Access Compliance Report

Public Rights-of-Way

(Curb Ramps)

Intersection ID: 5903	Main Street: MELLWOOD_DR	Cross Street: VALLEYDALE_RD	Location:	N
ADA ID: 0478506B6396	Ramp Type: Perp	Initial Pass/Fail: Fail	Overall Compliance: No	Severity Score: 10
Codes/Mitigation Info/Possible Solution		Field Measurements/Component Compliance

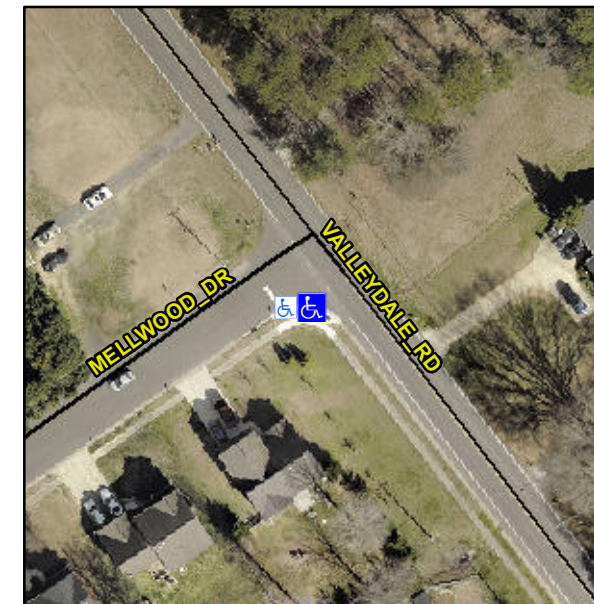
Not Found, R304.5.1, R304.5.3

Compliance	Description	Data	Compliance	Description	Data
N/A	Ramp Length (in)	49.0	Yes	Ramp Slope (%)	6.1
No	Ramp Width (in)	47.0	No	Ramp XSlope (%)	4.0
N/A	Flare Type LT	N/A	N/A	Flare Type RT	N/A
N/A	Flare Slope LT (%)	N/A	N/A	Flare Slope RT (%)	N/A
N/A	Flare Traversable LT?	N/A	N/A	Flare Traversable RT?	N/A
N/A	Landing Length (in)	N/A	N/A	DWS Provided?	N/A
N/A	Landing Width (in)	N/A	N/A	DWS Contrast?	N/A
N/A	Landing Slope (%)	N/A	N/A	DWS Length (in)	N/A
N/A	Landing X Slope (%)	N/A	N/A	DWS Full Width?	N/A
N/A	Landing Curb? (Y/N)	N/A	N/A	DWS Offset (in)	N/A
N/A	Shared Landing?	N/A			
N/A	Gutter Ponding?	N/A	N/A	Gutter Slope (%)	N/A
N/A	Gutter Lip Ht (in)	N/A	N/A	Gutter X Slope (%)	N/A
N/A	Painted X Walk1?	No	N/A	Painted X Walk2?	N/A
	X Walk 1 Direction	To NE		X Walk 2 Direction	N/A
N/A	X Walk 1 Width (in)	N/A	N/A	X Walk 2 Width (in)	N/A
	X Walk 1 Slope (%)	9.9		X Walk 2 Slope (%)	N/A
	X Walk 1 X Slope (%)	2.8		X Walk 2 X Slope (%)	N/A

Remove & Replace Entire Ramp.
